Pr	Product hierarchy no. *		archy no. *	Part no.	SBU	Type / Description	Customer part no.
SBL	PG	PUG	Туре				·
02	006	016	0000001535	See list below	Power Entry Module with Filter	DC12

Change of product and packaging label

Product Change Notification					PCN for DC12			
owner	creation date	release date	released by	change order no	rev	page	D40 040 765	
hotzar	2017-01-17	2017-02-03	blumhe	2011931	Α	1 of 2	D10-012-765

3 Detailed description of change

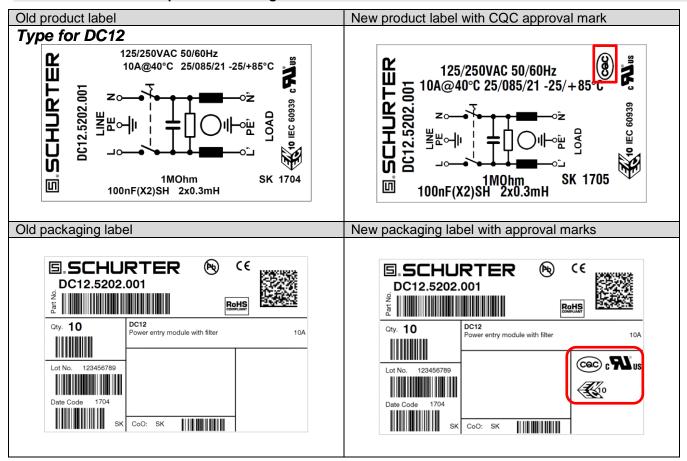
New approval mark for CQC.

Form	No	No change in form
Fit	No	No change for dimension
Function	No	No change in function
Manufacturing	No	No change for manufacturing site
Label	Yes	Approval mark adapted
Packaging	No	No change in packaging
